CITY PLANNING DEPARTMENT

Date: April 29, 2026

Re: 599 Reservoir Avenue – Crave Cafe

PROPOSED RESTAURANT INTERIOR & EXTERIOR RENOVATION

SITE PLAN

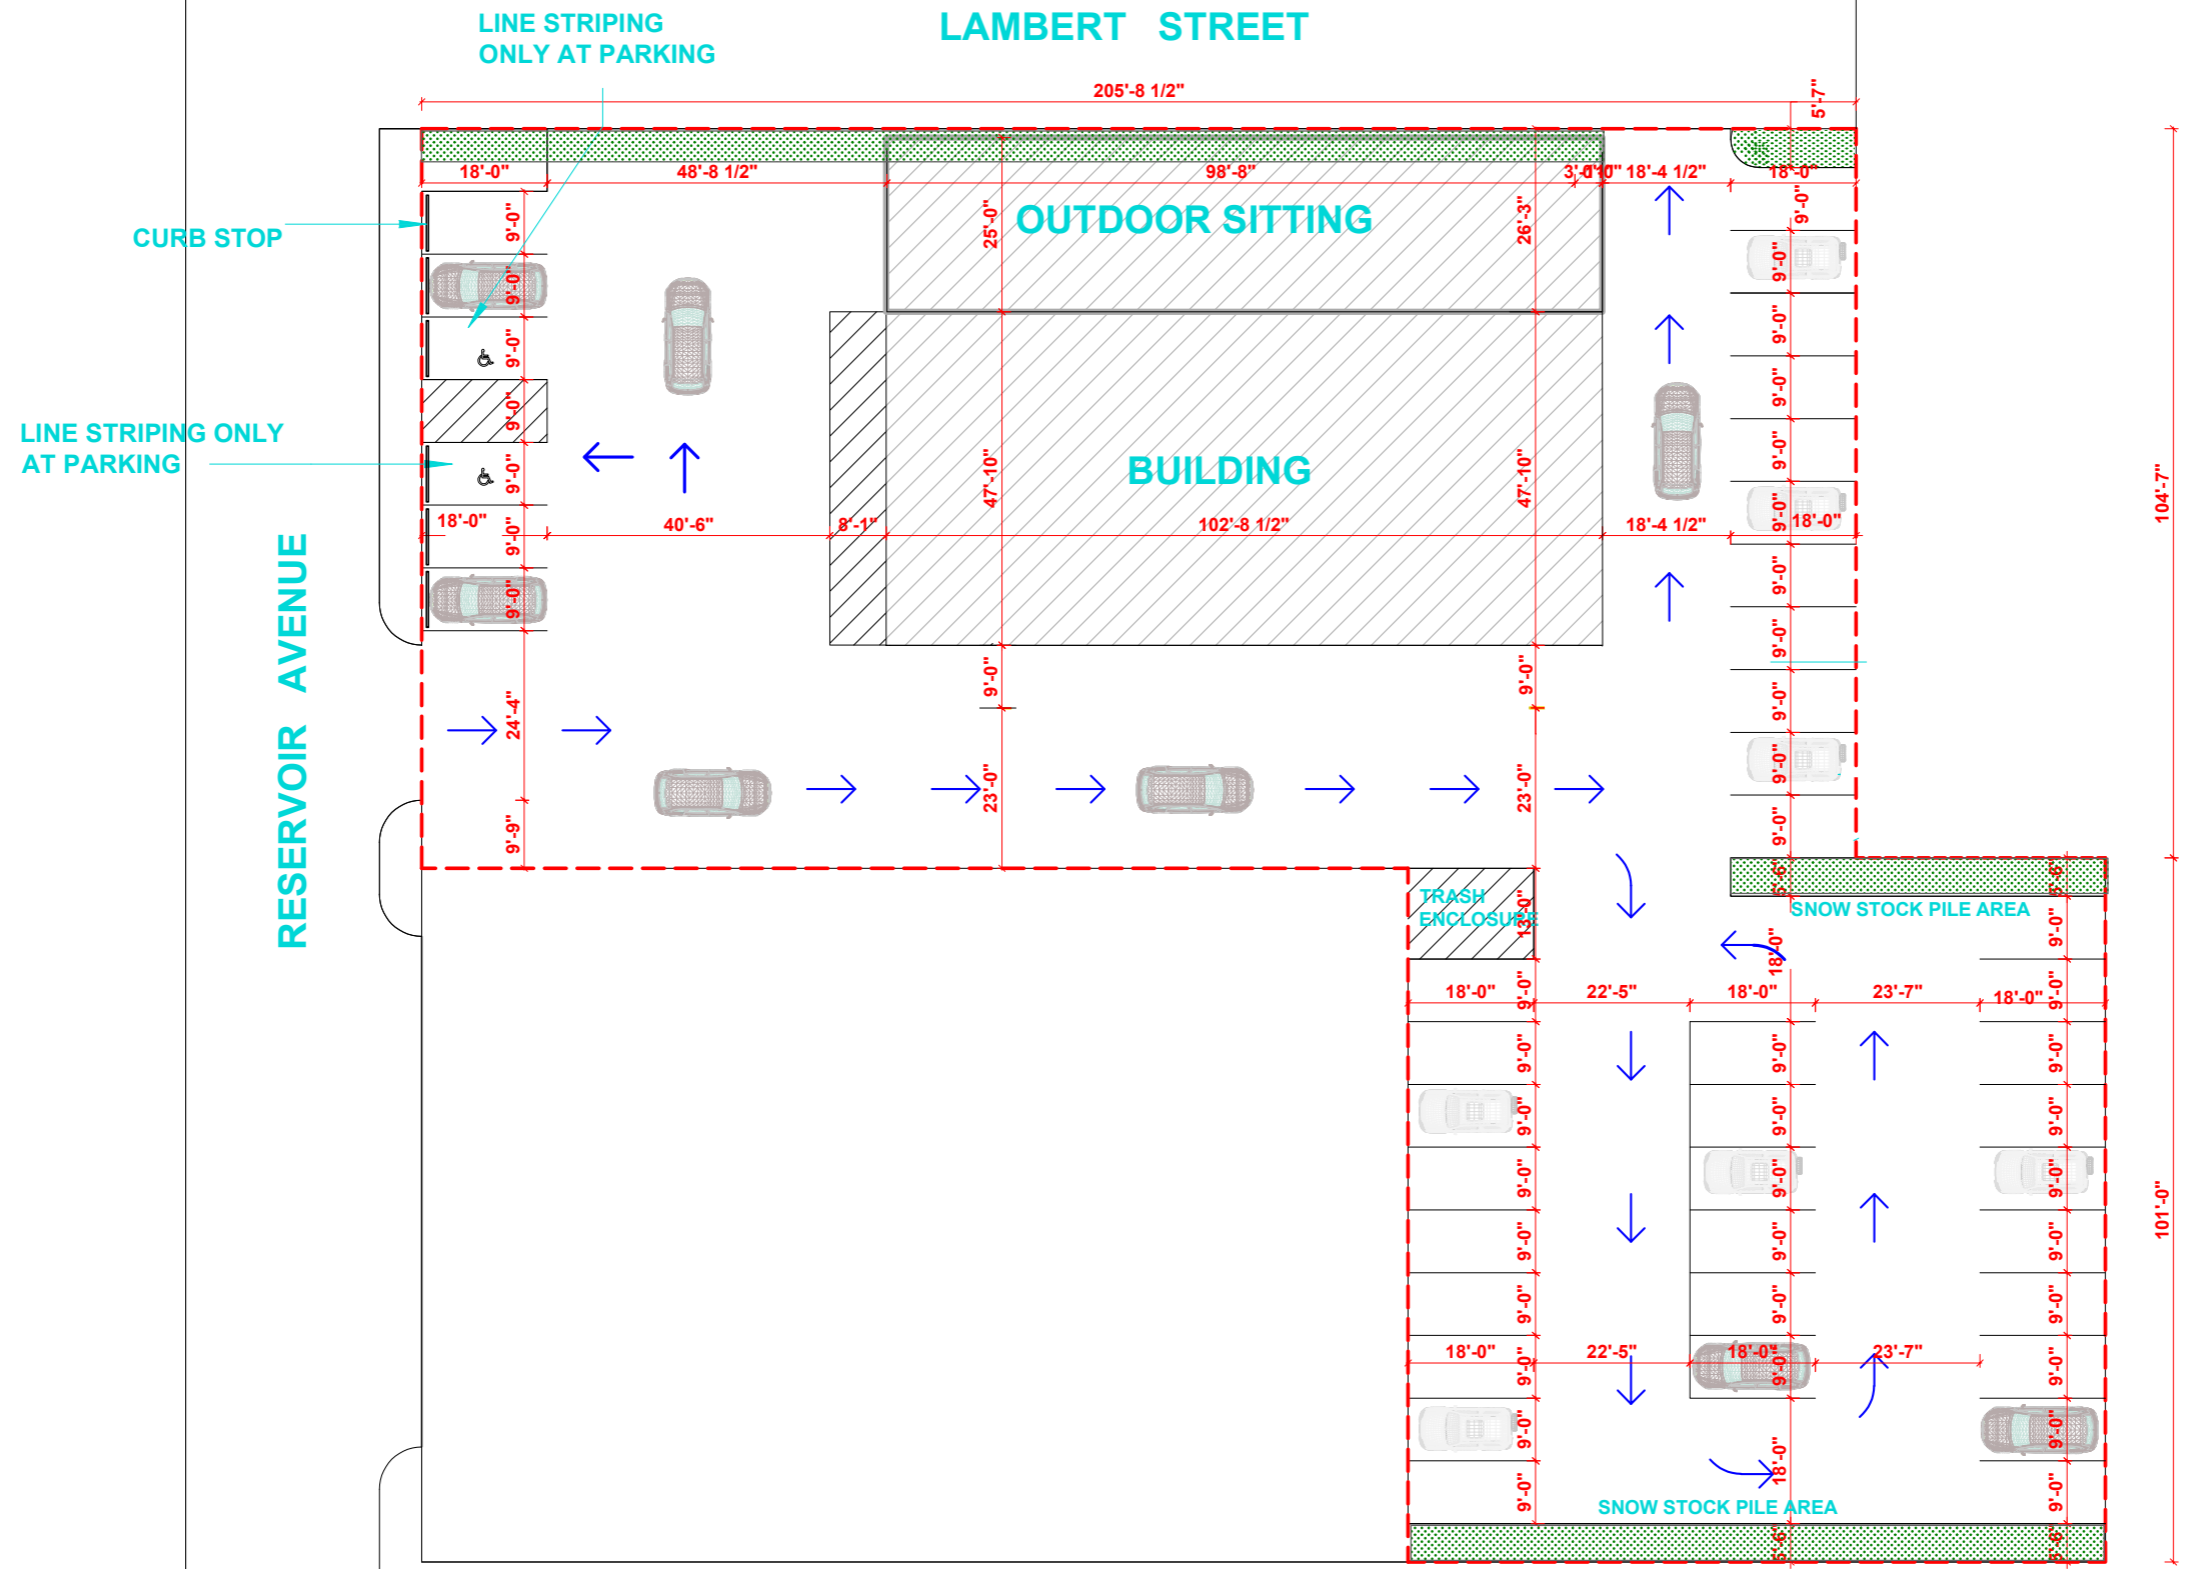
To ensure faster and smoother approval process, I strongly recommend removing the drive-through component from the proposal. The site presents several constraints that make a drive-through difficult to accommodate, including insufficient drive aisle width, inadequate turning

radius around the building, and conflicts between backing vehicles and the drive-through lane. Additionally, a drive-through triggers the requirement for five additional parking spaces. Collectively, these issues are likely to create significant challenges during review and could delay or prevent approval. This feature could be reconsidered in the future if a more viable design solution is developed.

Regarding site access, the proposal currently includes three curb cuts: two exits onto Lambert Street and one entrance from Reservoir Avenue. I support the closure of one existing curb cut on Reservoir Avenue, leaving a single entrance there. However, I recommend also closing the Lambert Street curb cut closest to the corner of Lambert Street and Reservoir Avenue. Even though it is an existing nonconformity, reducing curb cuts near intersections improves overall safety and site circulation.

For the proposed outdoor dining area, while the City does not have specific regulations beyond parking requirements (one space per three seats), safety remains a key consideration. I recommend incorporating physical separation elements such as planter boxes or similar barriers to clearly distinguish the outdoor seating area from vehicular circulation and the street edge.

Additionally, the sidewalks along Lambert Street in the surrounding residential area are in good condition. I encourage you to reflect in your updated plans an intent to continue and enhance these sidewalks, including curbing and, where feasible, small landscaped green strips. This will contribute positively to the public realm and support a more walkable, cohesive streetscape.

Lastly, the current plan set does not indicate a designated dumpster location. This will need to be included, ensuring that it meets City standards for placement, access, and screening.
